Response to Anonymous Referee #1 Comments

Review of The CALIPSO version 4.5 stratospheric aerosol subtyping algorithm by Tackett et al.

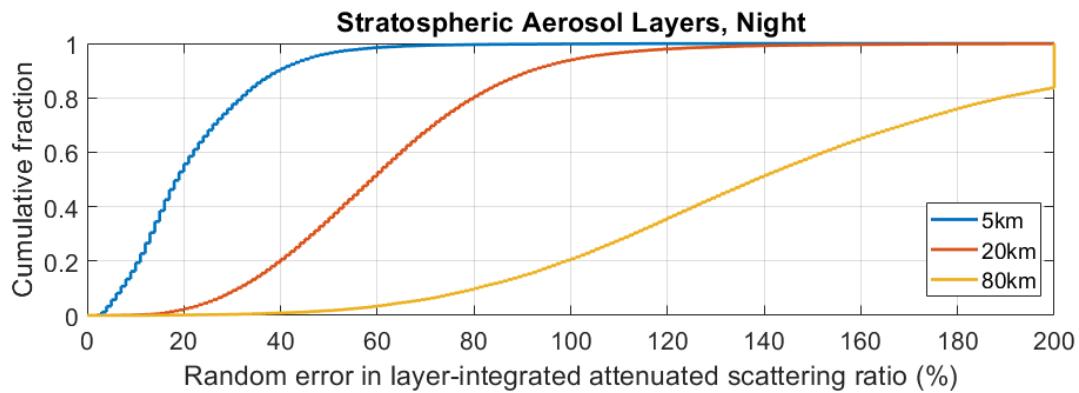
Second, I think there should probably be some emphasis on the idea that the errors in the estimated particulate depolarization ratio are dominated by systematic rather than random errors, and possibly some analysis or demonstration of why estimated particulate depolarization ratio is nevertheless necessary for classification or better than volume depolarization, which is more likely to be strongly dominated by random rather than systematic errors.

Indeed, there are systematic uncertainties in CALIOP's estimated particulate depolarization ratios, and we agree that they should be discussed in the manuscript. However, the relative contribution of systematic errors compared to random errors in CALIOP data are not the same as for the HSRL error budget discussed in Burton et al., 2015. The equation below, adapted from Eqn. A5 of Burton et al. 2015, shows the error propagation for Eqn. 2 in our manuscript.

optical path between the lidar and measurement range r . Burton et al. (2015) can use R because the HSRL directly measures R . CALIOP directly measures R' , but can only obtain R after making in-layer attenuation corrections (i.e., computing $T_p^2(r)$), which requires a priori specification of a lidar ratio. These lidar ratios are one of the primary outputs of the stratospheric aerosol subtyping scheme. The calculation of δ_p^{est} , on the other hand, is one of the essential inputs. Additional details have been added to Sect. 3 describing the relationship between R and R' .

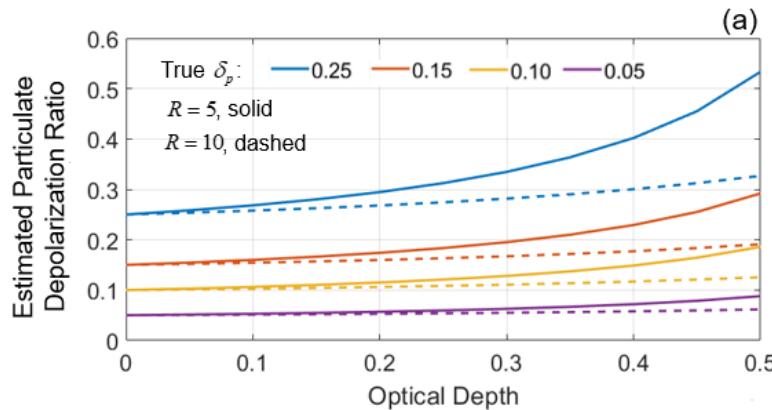
L58 mentions the algorithmic motivation for getting the right aerosol type is the need to correct the overlying attenuation. How sensitive are the retrievals lower in the atmosphere to having the correct type in the stratosphere? That is, I realize there is a one-to-one relationship between error in layer lidar ratio and the error in the AOT for the same layer, but can the authors describe how much the uncertainty for lower layers is increased given the distribution of stratosphere layer optical thickness? This would address not just correct typing, but also how much impact changing the volcanic ash lidar ratio would be expected to have.

We chose to add this information to Sect. 4.5 which discusses lidar ratios to avoid bogging the introduction down in too many details. Here is the new paragraph that now starts off Sect. 4.5:

“As emphasized in the introduction, the algorithmic motivation for improving aerosol subtyping is to ensure that a representative lidar ratio is selected for that subtype, thereby yielding accurate extinction retrievals. Because CALIOP retrievals operate from top-down, any errors in the retrieved extinction due to incorrect lidar ratio selection will propagate into underlying layers. The previous subsections described the improvements we made to increase the likelihood that the correct stratospheric aerosol subtype (i.e., correct lidar ratio) will be selected. However, it is also important that the lidar ratio for these subtypes are representative of what is observed in nature. A full, detailed accounting of error propagation in CALIOP extinction retrievals is given in Young et al., 2013, including the impacts of incorrect lidar ratio selection. One key take-away from that paper is that the relative error in retrieved AOD equals the relative error in the lidar ratio for layers having low optical depths, typical of aerosol. A second key take-away is that the error in retrieved

AOD due to incorrect lidar ratio selection behaves as a systematic bias in the retrieval of optical depth for underlying layers. The magnitude of the error in AOD for the underlying layer depends on its R' , AOD, and the magnitude of the error in lidar ratio of the overlying layer. In general, though, the sign of the AOD bias is the same as the sign of the error in lidar ratio selection of the overlying layer (i.e., selecting too low of a lidar ratio causes an underestimate in AOD of layers at lower altitudes). Feature detection accuracy for lower layers can also be degraded if overlying attenuation is not correctly accounted for. Clearly, accurate lidar ratio selection is critical for elastic backscatter lidar retrievals.”

Figure 6. Same joint distributions as Fig. 4, but for layers classified as PSA in the southern hemisphere in 2013, based on V4.5 data.

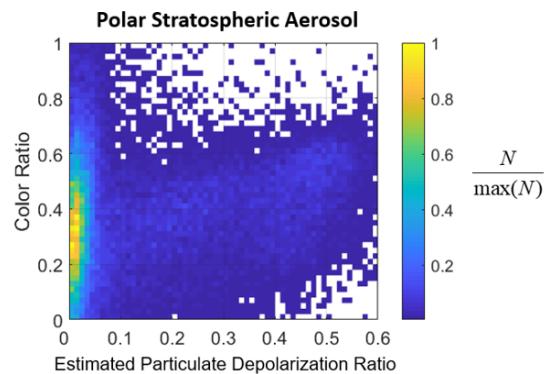
Figure 3. I'm curious to see a panel which shows a representative selection of known PSA, which would help illustrate why the PSA selection must be done before thresholding on depolarization.

This suggestion was very helpful. We added the figure below to this section which showed quite a broad range in depolarization values. With this as a basis, we modified our rationale in the text to, "These layers are often detected adjacent to features classified as cloud and have depolarization levels that overlap with the expected ranges for sulfate, smoke, and ash (Fig. 6)... The PSA classification prevents these layers from being misclassified as volcanic ash or sulfate when none exists."

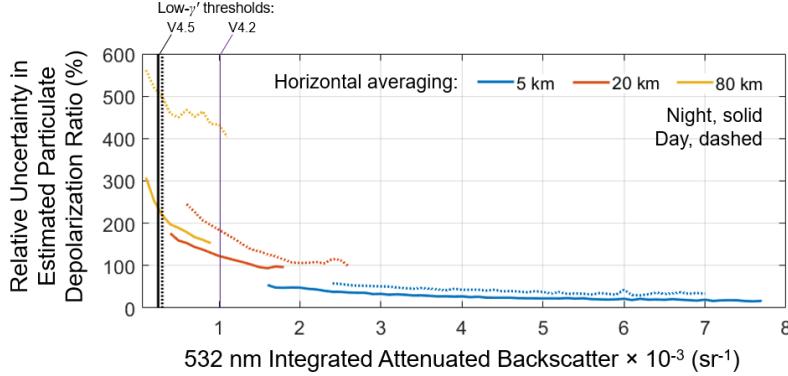
L365-366 "The lowest quartile... was selected so that the average relative uncertainty in estimated particulate depolarization is less than 250%" (and following text). While I'm not surprised by very large uncertainties in estimated particulate depolarization ratio for small signal levels, it's not immediately obvious how an uncertainty of more than 100% is particularly useful, and whether it should make any practical difference if the uncertainty is 200% or 400%, especially given that sulfate has essentially zero depolarization and therefore always has a large relative uncertainty. However, the uncertainty in the estimated particulate depolarization is strongly dominated by systematic, rather than random, uncertainty, particularly for small values of the attenuated scattering ratio, due to the mathematical form of Eqn 2 (see, e.g. Burton et al. 2015) which is a strong and valid reason for wanting to cut off this calculation at values before the systematic error blows up. I think the discussion would be clearer and more informative if the discussion explicitly refers to this systematic uncertainty from Eqn 2 and perhaps includes a figure showing how the resulting uncertainty depends on the attenuated backscatter.

Indeed, a visualization would help make the message clearer and add more information. To acknowledge the rapid increase in uncertainty for low IAB values, we added these sentences,

"At low signal levels, δ_p^{est} becomes prone to increases in systematic and random errors along with the increased risk of overestimates as discussed in Sect. 3....The lowest-quartile γ'_{532} metric was selected based on the rapid increase in relative uncertainty in δ_p^{est} as a function of decreasing γ'_{532} (Fig. 12)."

Here is the new Fig. 12 which shows the old and new thresholds and how they relate to the relative uncertainty in δ_p^{est} . Adding this figure adds valuable information, that the average relative uncertainty for stratospheric aerosol layers detected at 5 km resolution is less than 50%. A sentence is added to the section to note this.

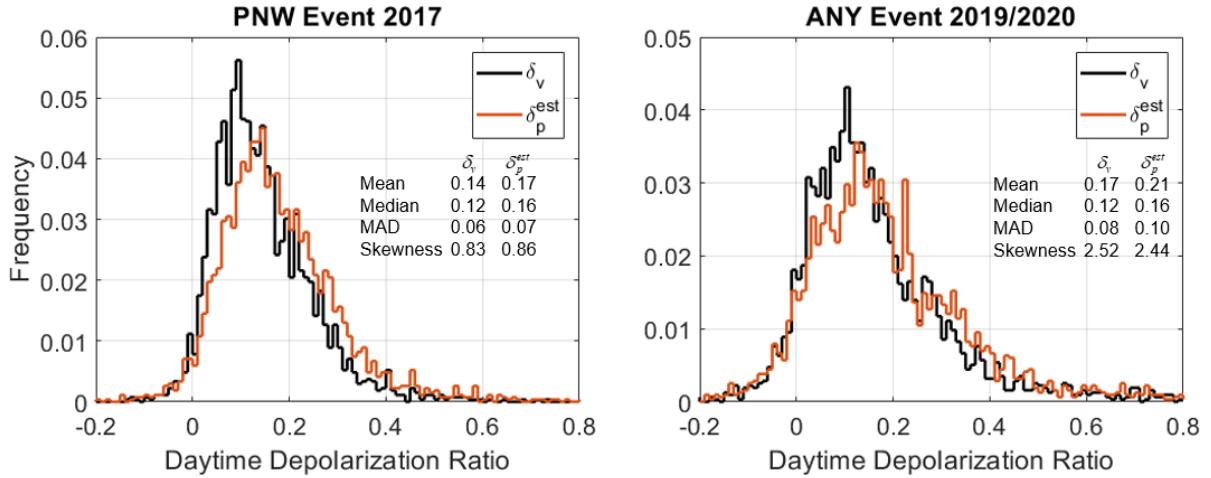
L618-619 "This reflected sunlight enhances noise throughout the profile overhead, thereby increasing the variability of depolarization ratio measurements". It's clear that noise would increase the variability of the depolarization measurements, including volume depolarization, but why does it produce an asymmetric tail with more large values? Is this because the negative branch is cut off (I mean if negative depolarizations were reported and graphed would there be a symmetric tail on that side?) or is it related to the propagation of error from the volume depolarization to the estimated particulate depolarization? By which I mean, if the volume depolarization distributions are plotted, are they wider during the day but still symmetric? If so, then, considering that noise also increases the variability in R' , perhaps the issue is again the R' errors propagating non-linearly through Eqn 2, so that a symmetric distribution of error in R' (plus a symmetric distribution of volume depolarization) becomes an asymmetric distribution of particulate depolarization.

The asymmetric tail in the daytime depolarization is inherent to the volume depolarization ratio. The figures below compare the volume and estimated particulate depolarization ratios for the two events in Fig. 21 (previously Fig. 18 in the initial submission). The statistics on the charts show

that the breadth and skewness did not change appreciably or at least enough to confidently attribute the asymmetric tail to amplification of systematic errors in R' through Eqn. (2). However, we agree that the negative depolarization should be shown to clearly represent the distributions. For this, we reduced the lower limit of depolarization on the x-axis of Fig. 21 so that the negative depolarizations are shown.

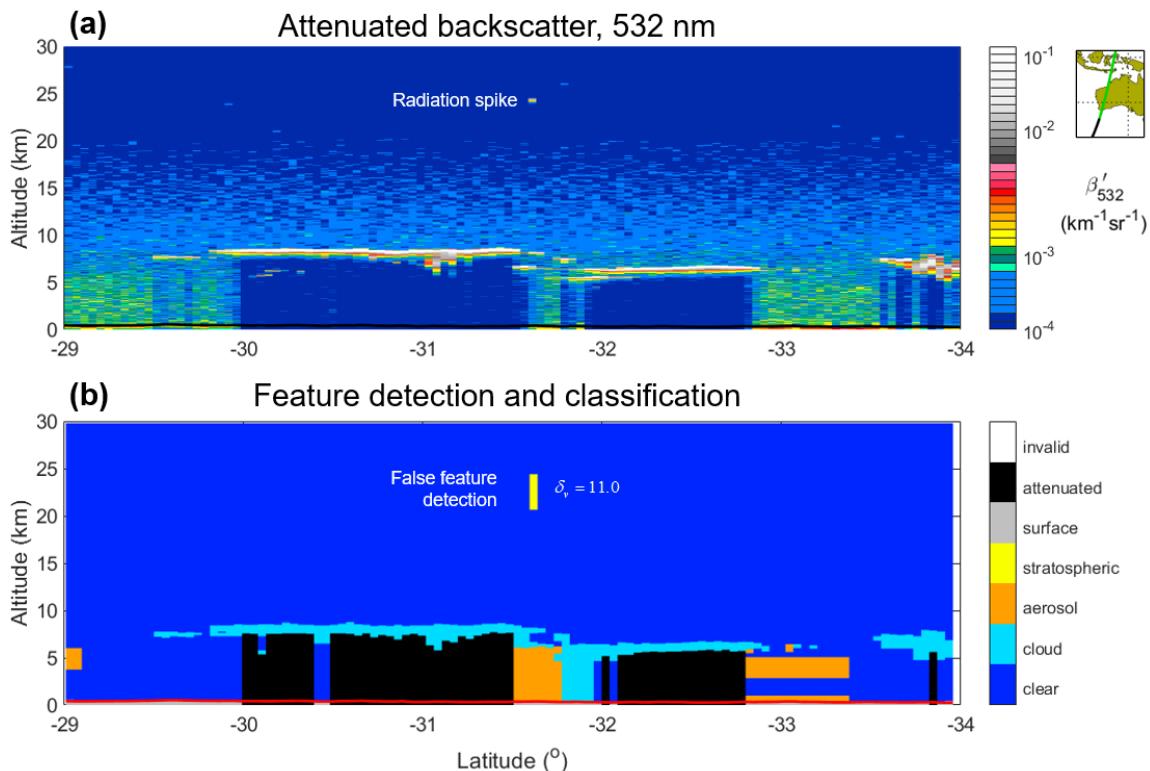
L656 "The aerosol subtypes of these false layer detections" I'm confused whether these percentages refer to the whole population of false layer detections, or only to the subgroup that remains after filtering for the SAA and low CAD scores. If they include the low CAD group, then is it likely that the dominance of high-depolarization aerosol types might reflect mistyped cloud? Does the percentage classified as ash remain so remarkably high after the low CAD cases are taken out? If so, why should these non-layers be dominated by large depolarizations?

The following figures have been added to the supplement to show representative examples of false feature detections in CALIOP data. The first example Fig. S6 is a false detection due to a radiation-induced current spike in the 532 nm channel detector(s) (Hunt et al., 2009). Because the volume depolarization is so high for this layer, it is likely that the perpendicular channel was affected by the current spike and not the parallel channel. The second example Fig. S7 is daytime over the South Atlantic Anomaly region where excess radiation more commonly affects the CALIOP

“These layers are primarily located inside the SAA. Outside the SAA, a relatively small number of layers are randomly distributed over the globe (Fig. S5). Because they do not occur within specific latitude bands, as would legitimate layers associated with specific events, they are likely due to false layer detections caused by radiation-induced current spikes in the 532 nm channel detectors (Hunt et al., 2009; e.g., Fig. S6) or enhanced background noise from sunlight reflecting off underlying clouds in the daytime (e.g., Fig. S7). The aerosol subtypes of these false layer detections at night are 54 % ash, 30 % sulfate, 5 % smoke, and 11 % unclassified. During the day, these frequencies change to 84 % ash, <1 % sulfate, 3 % smoke, and 13 % unclassified. The propensity for ash classification is due to excess solar background noise broadening the distribution of depolarization values to create artificially high values and from cases of radiation-induced current spikes which only affect the 532 nm perpendicular channel, but not the parallel channel.”

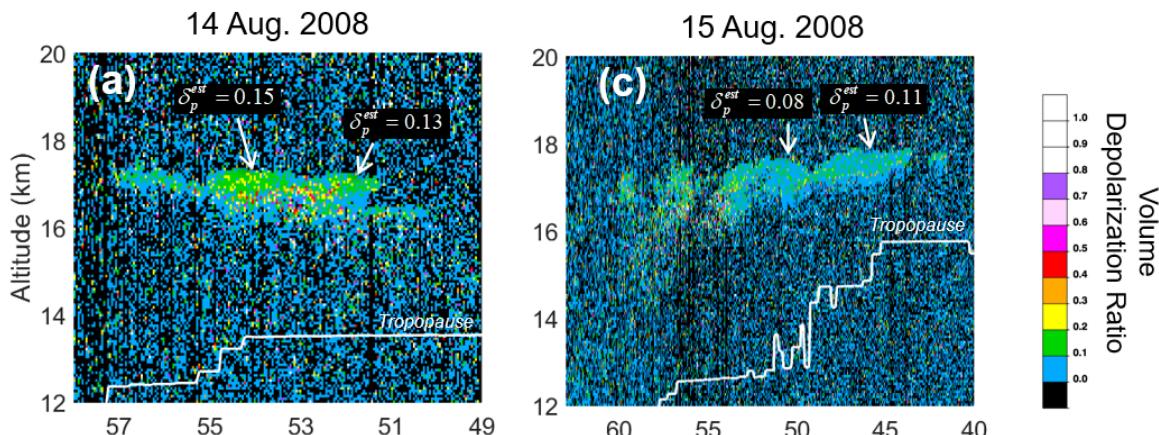
Figure 16. It’s somewhat confusing that this shows volume depolarization ratio when the text primarily discusses estimated particulate depolarization ratio.

We prefer to show the volume depolarization ratio because it shows the range-resolved structure of depolarization. The estimated particulate depolarization ratio is only computed based on layer-averaged quantities in CALIOP processing, so the variability in depolarization would not be as obvious if estimated particulate depolarization ratio were plotted. In order to better give the sense of its value, call-outs were added to each figure giving representative values of estimated particulate depolarization for different parts of each plume.
